ADDENDUM #1

NORTH PLATTE COMMUNITY COLLEGE SOUTH CAMPUS CAFETERIA ADDITION NORTH PLATTE, NEBRASKA 1001

Date Issued: March 13, 2013

1 LIGHTING PLAN - FIRST FLOOR
SCALE: 1/8" = 1'-0"

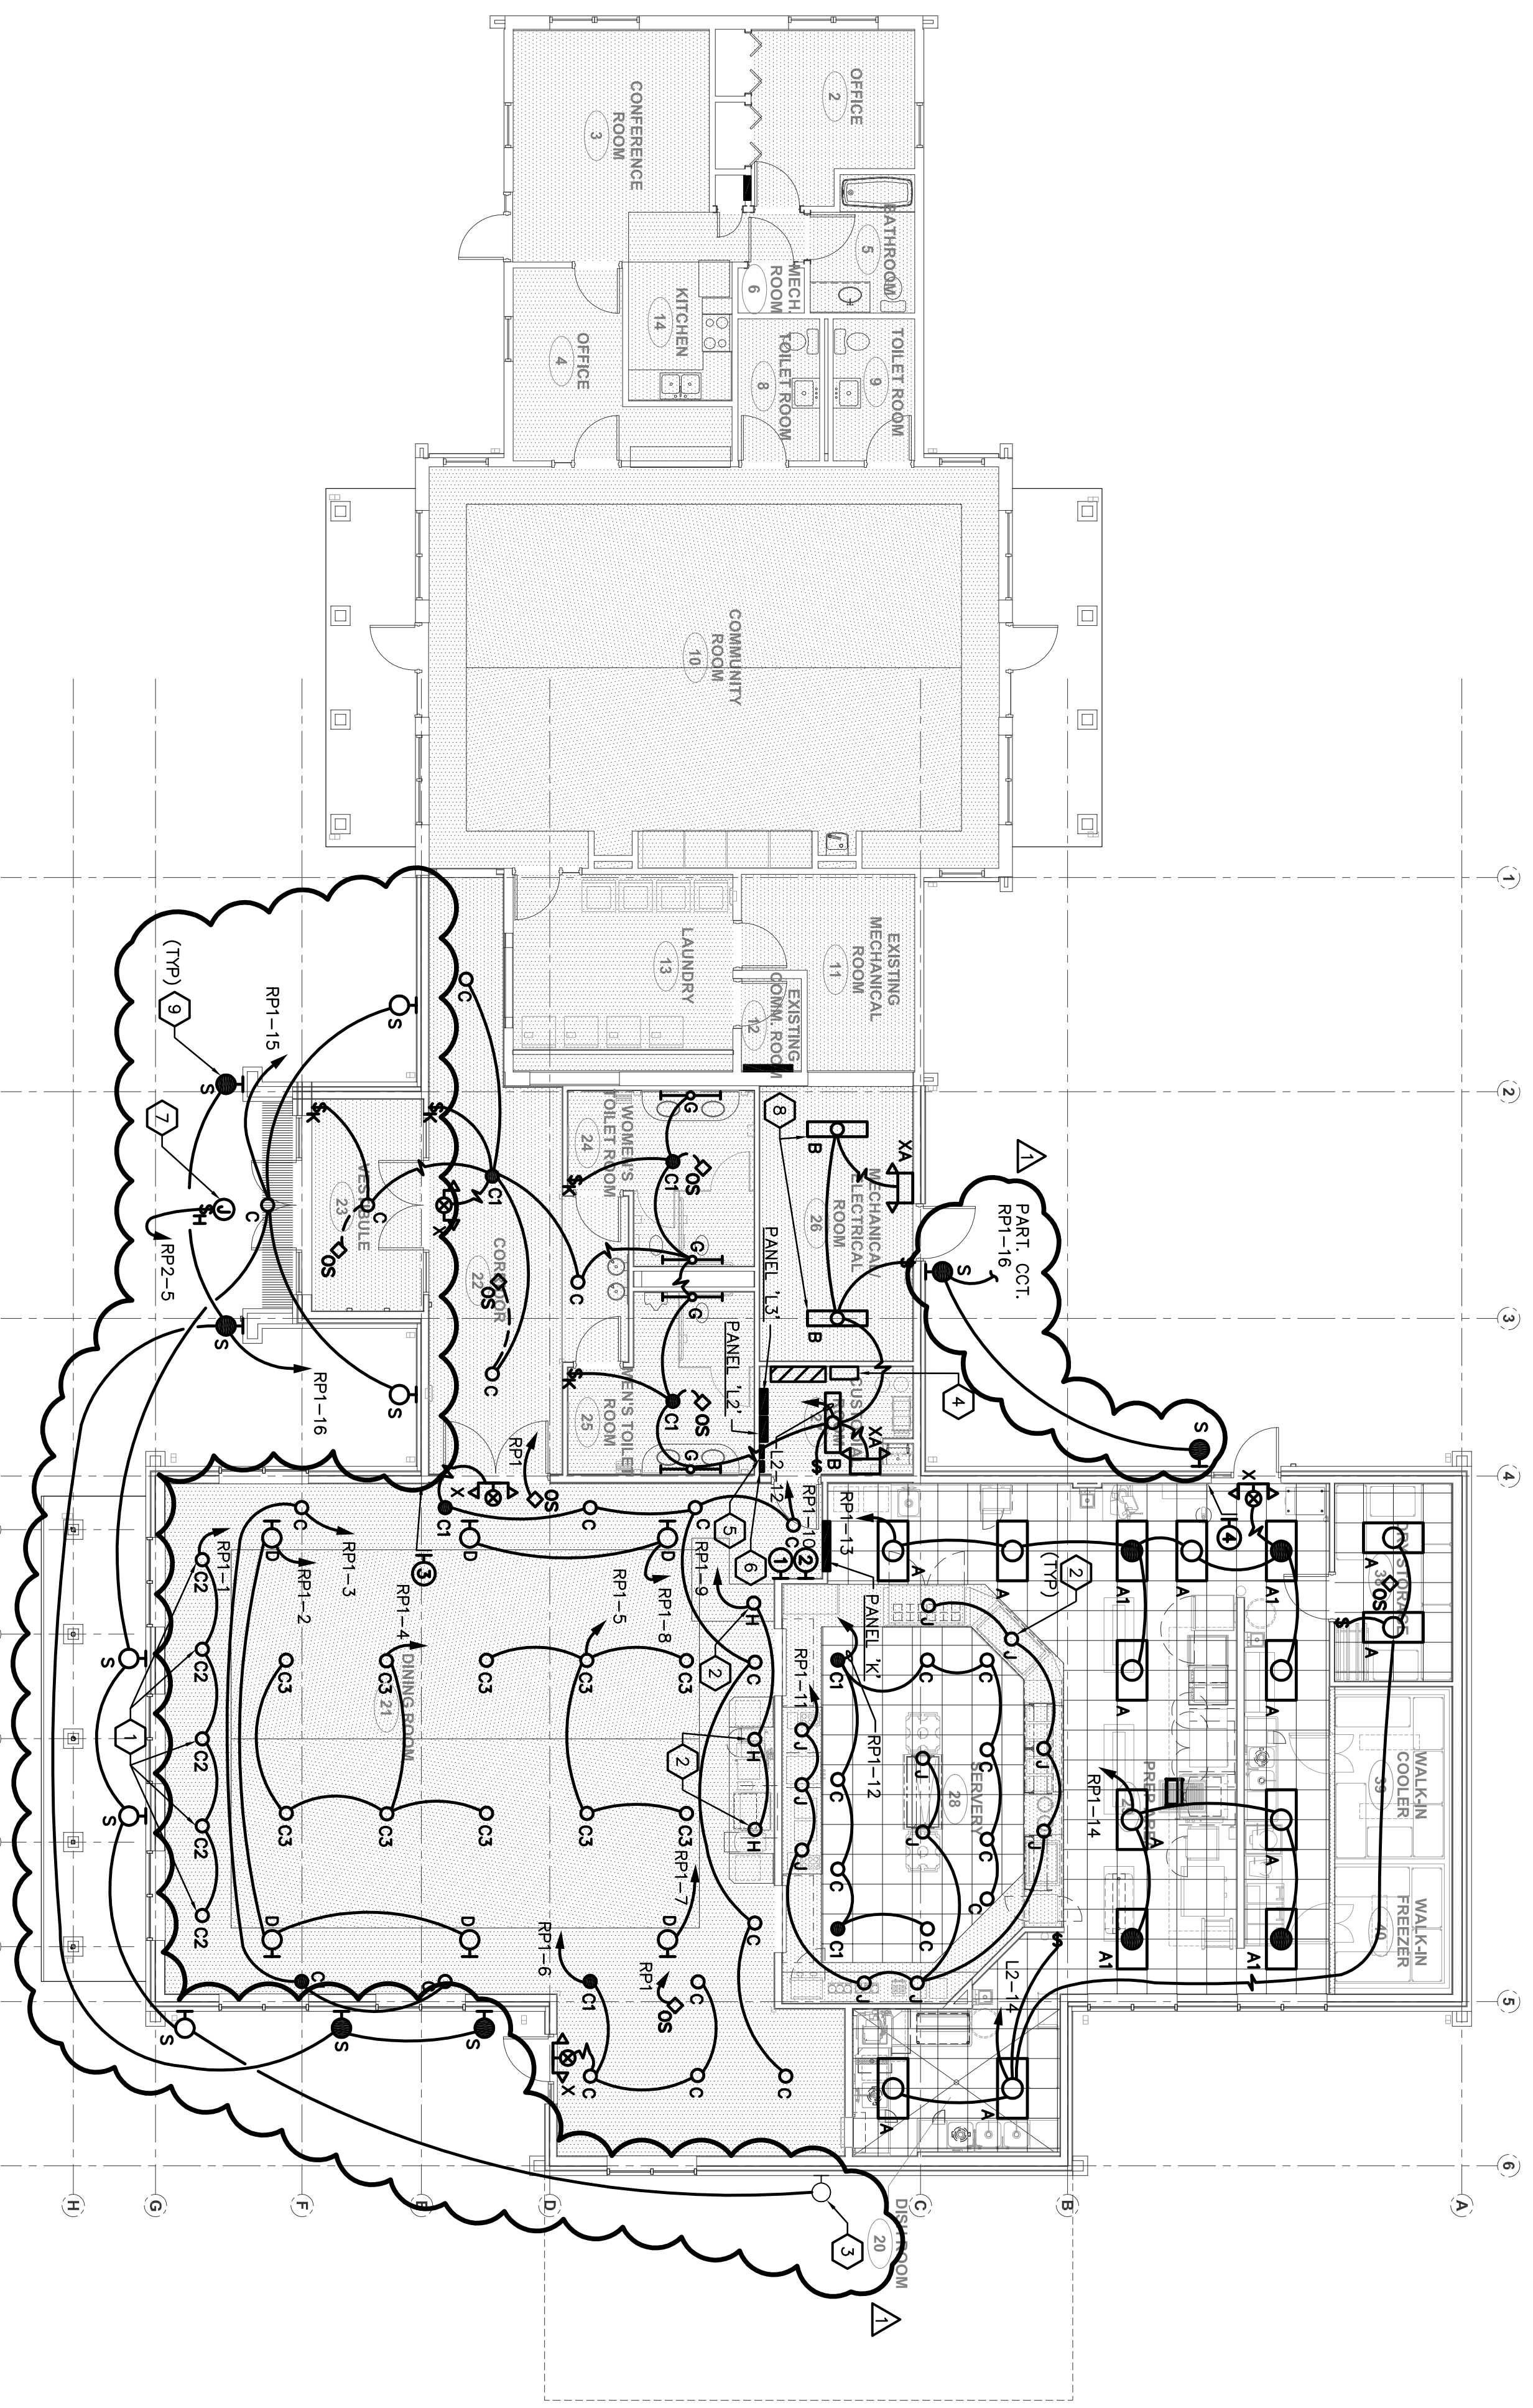
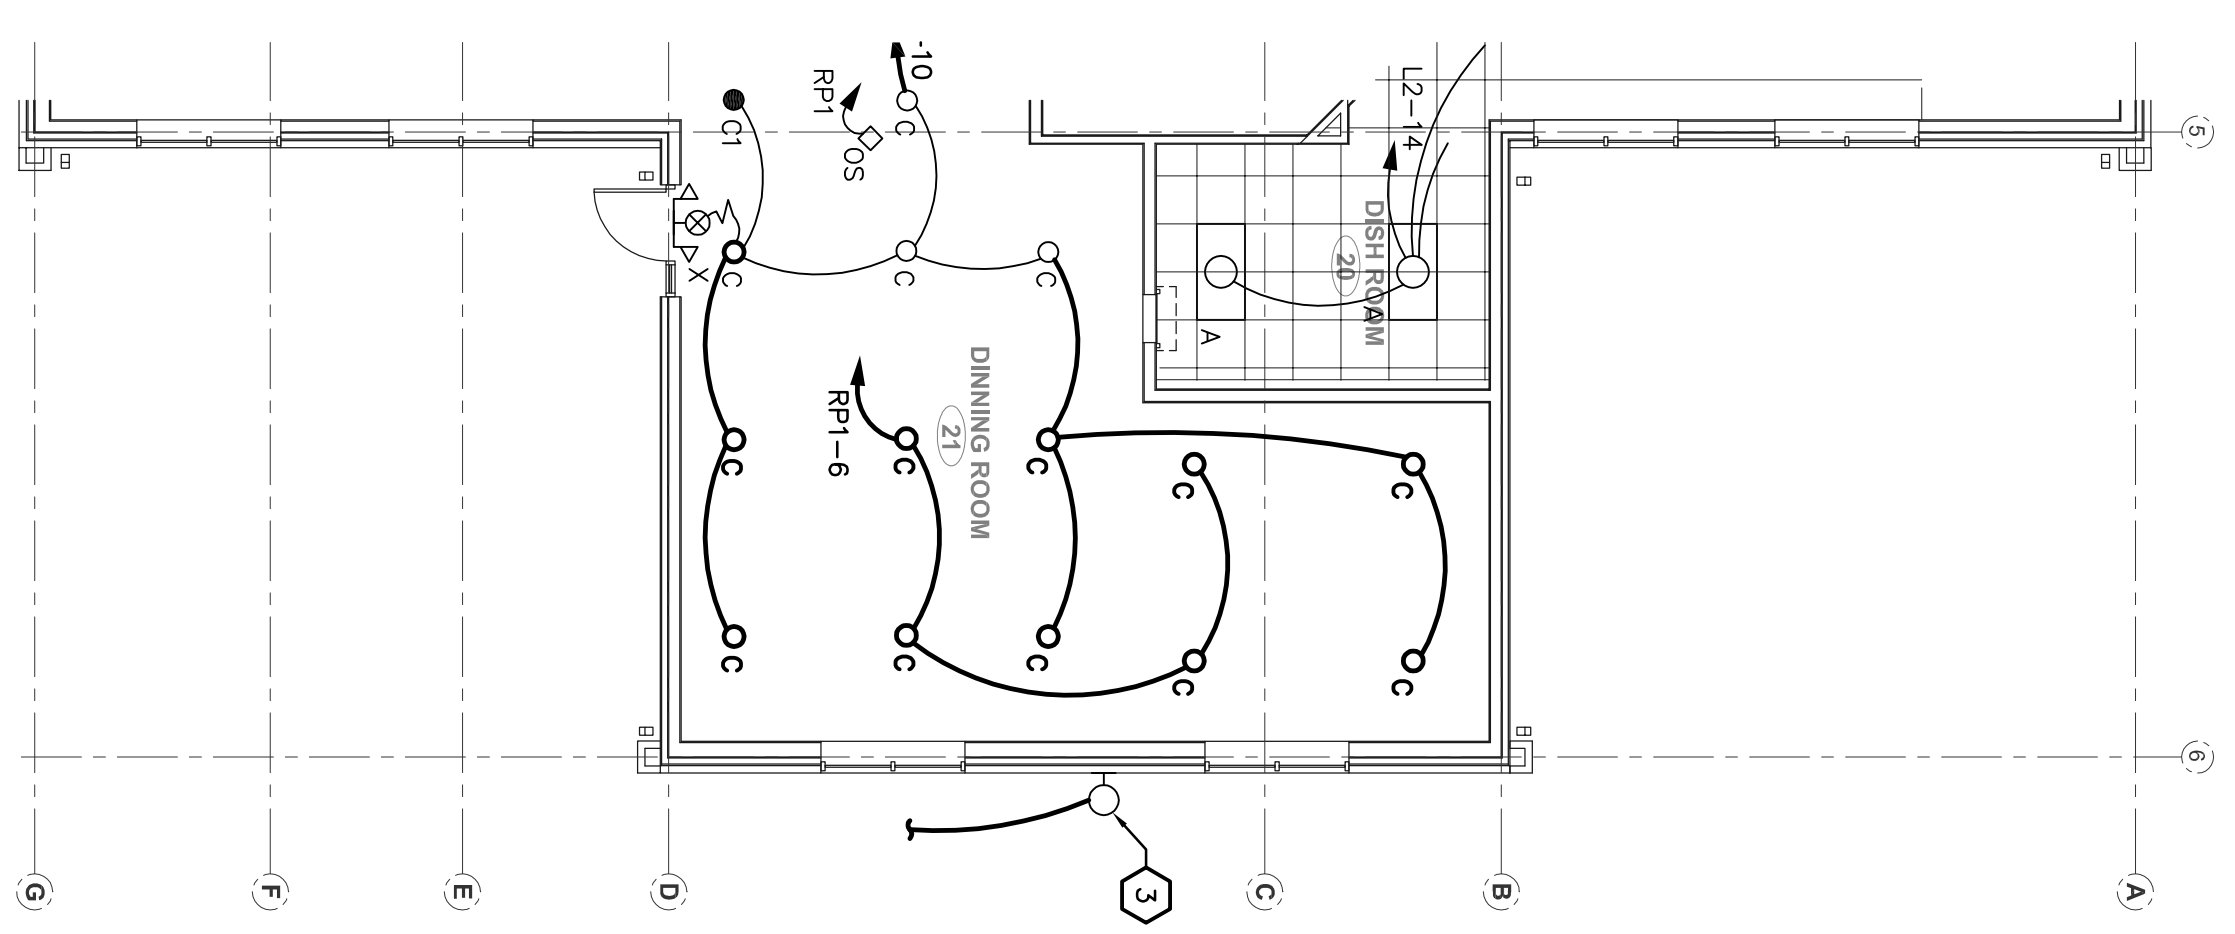
- Addendum #1 - #14 SHEET EL1.1 – LIGHTING PLAN - FIRST FLOOR**
Revise Keynote 7 to read: Contractor shall be responsible for relocating the existing box sign to this location. Coordinate requirements of sign prior to rough-in. Provide appropriate local disconnecting means mounted in an accessible, inconspicuous location that is within sight of the sign.

- Addendum #1 - #15 SHEET EL1.1 – LIGHTING PLAN - FIRST FLOOR**
Refer to the attached sheet for the revised exterior lighting circuiting and additional luminaires.

- 7 CONTRACTOR SHALL BE RESPONSIBLE FOR RELOCATING THE EXISTING BOX SIGN TO THIS LOCATION. COORDINATE REQUIREMENTS OF SIGN PRIOR TO BOOTH CONSTRUCTION. LOCAL DISCONNECTING MEANS SHALL BE PROVIDED WHERE NECESSARY. INCONSPICUOUS LOCATION THAT IS WITHIN SIGHT OF THE SIGN.

ELECTRICAL SITE PLAN
SCALE: 1/8" = 1'-0"

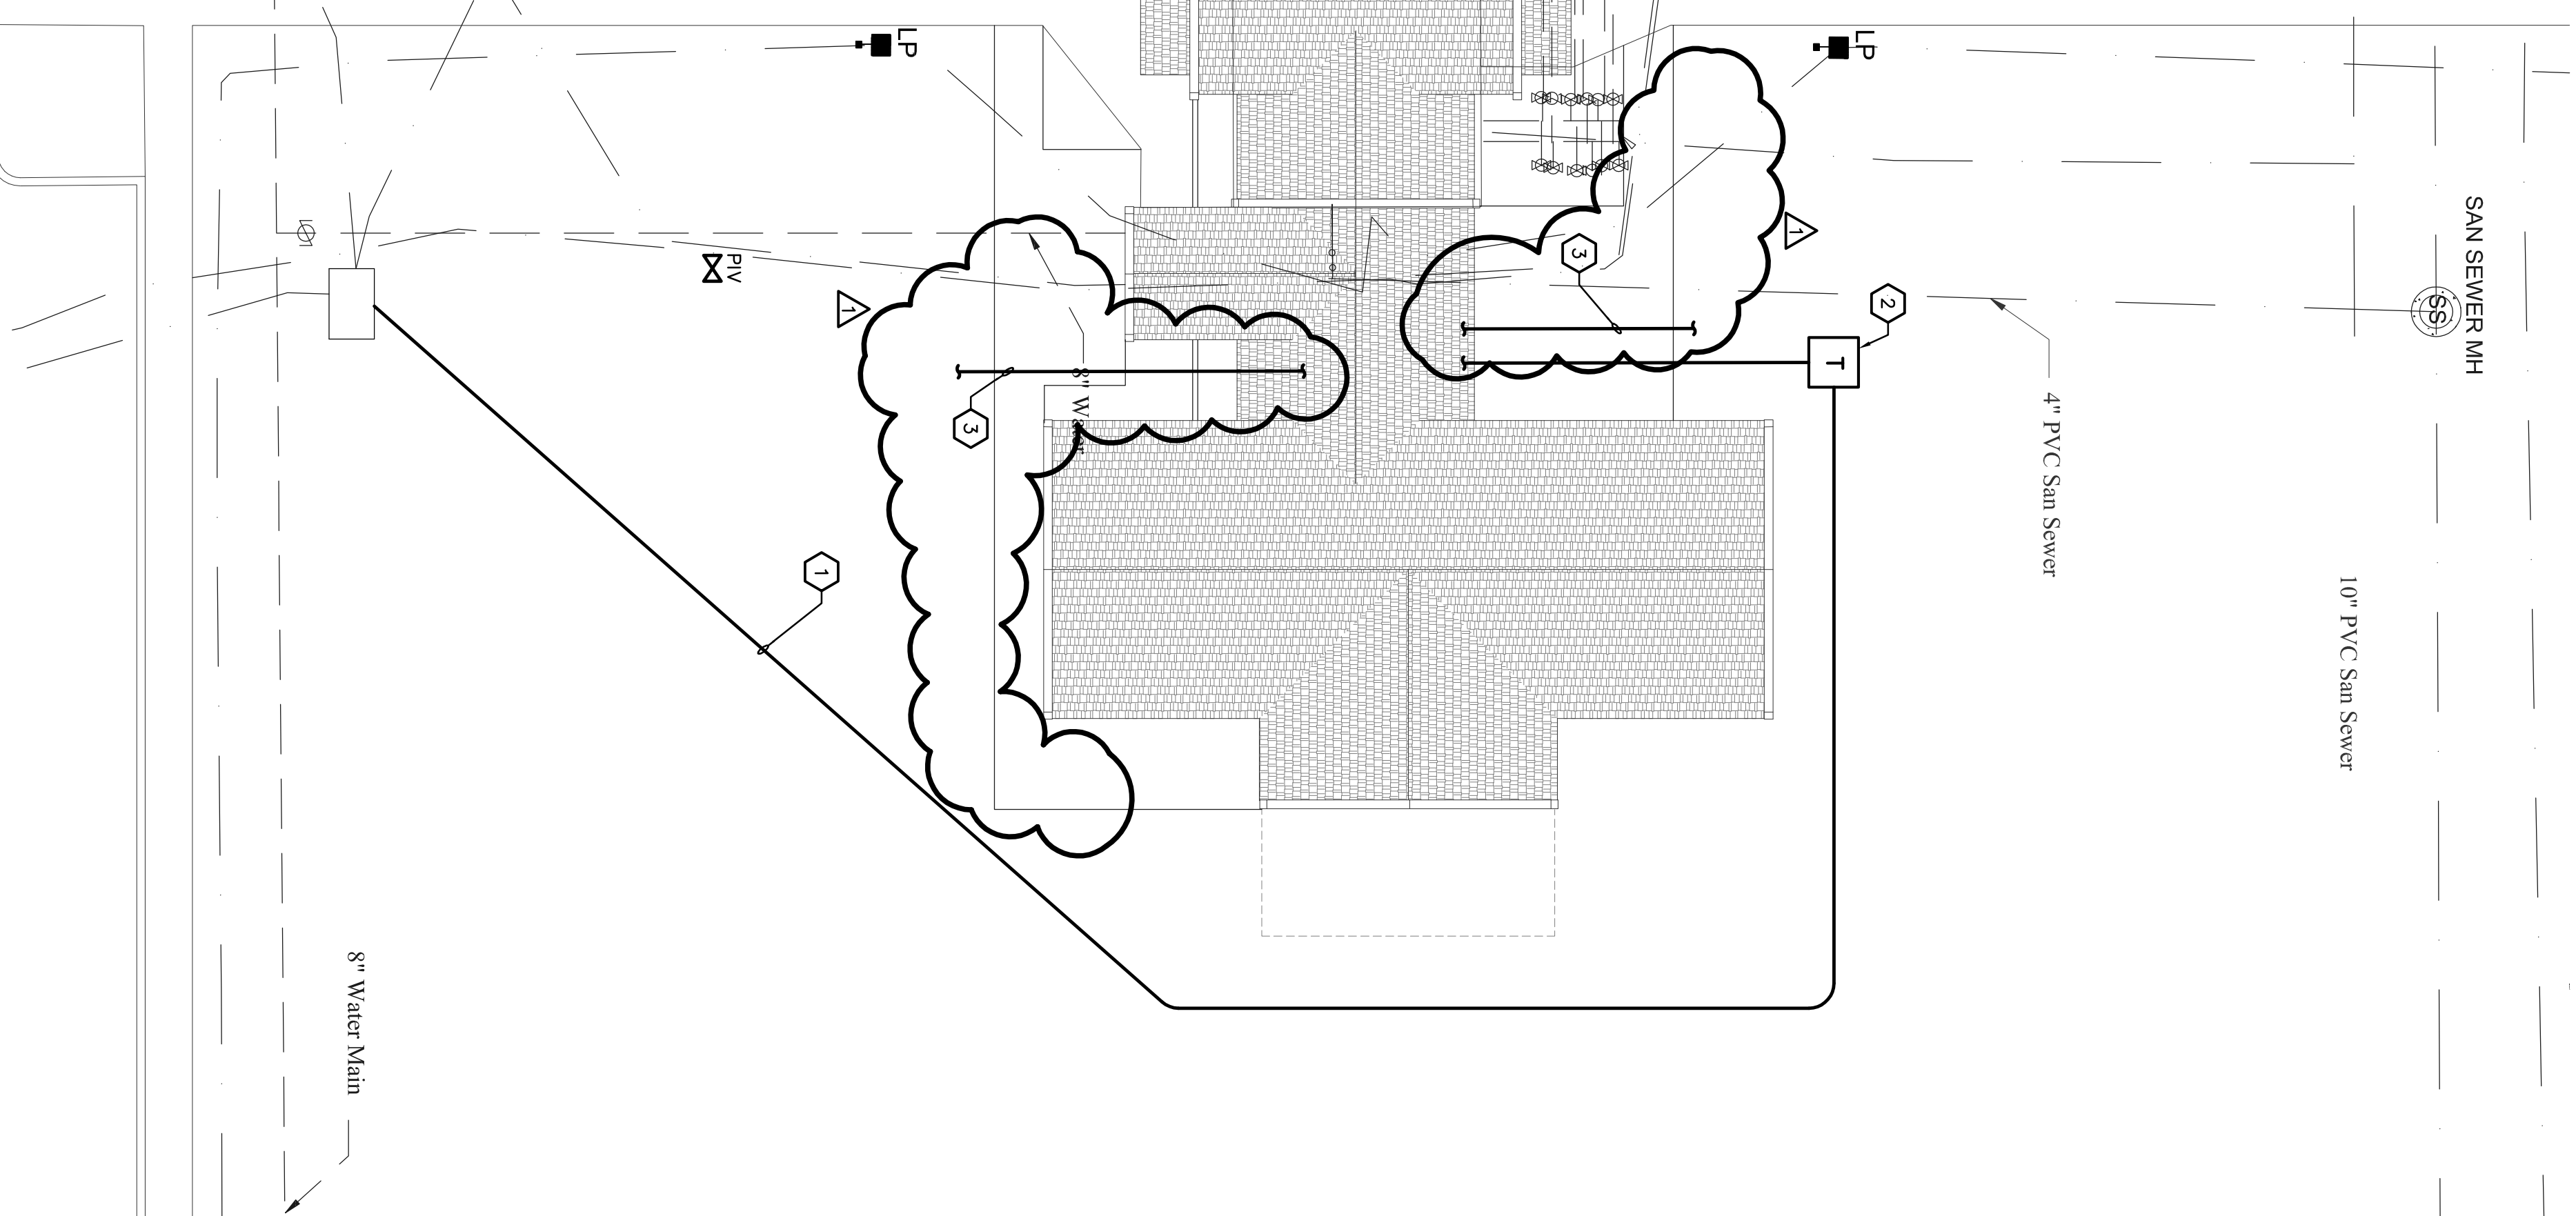
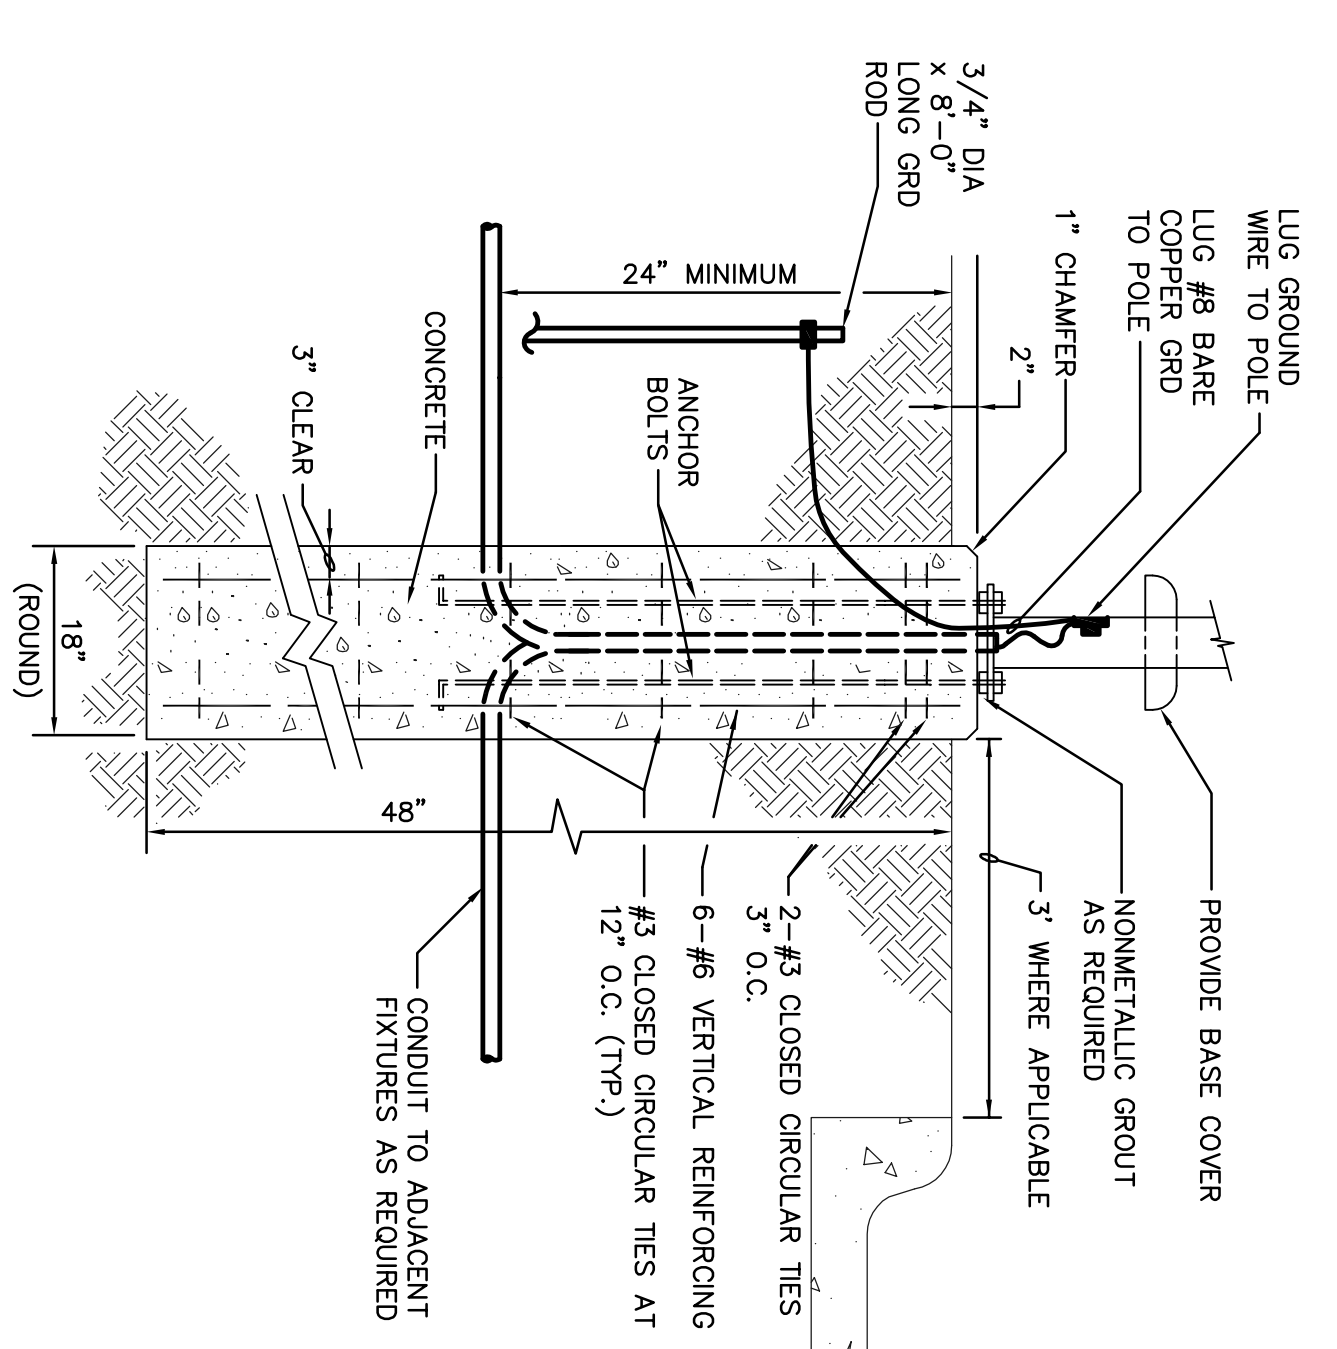
- Addendum #1 - #17 SHEET ES1.1 – ELECTRICAL SITE PLAN**
Provide a 1” conduit stubbed out the north and south side of the building for future site lighting by owner. Remove the existing type S2 luminaires, poles and bases from the project.

- ELECTRICAL KEYNOTES:** ()
- ① CONTRACTOR SHALL PROVIDE 4" CONDUIT WITH PULLSTRING. COORDINATE REQUIREMENTS WITH UTILITY COMPANY.
 - ② CONTRACTOR SHALL PROVIDE TRANSFORMER PAD. COORDINATE REQUIREMENTS WITH UTILITY COMPANY.
 - ③ STUB 1" CONDUIT OUT TO GRASS AREA FOR FUTURE SITE LIGHTING. CONDUIT SHALL BE STUBBED INTO CUSTODIAL ROOM NEXT TO PANEL.
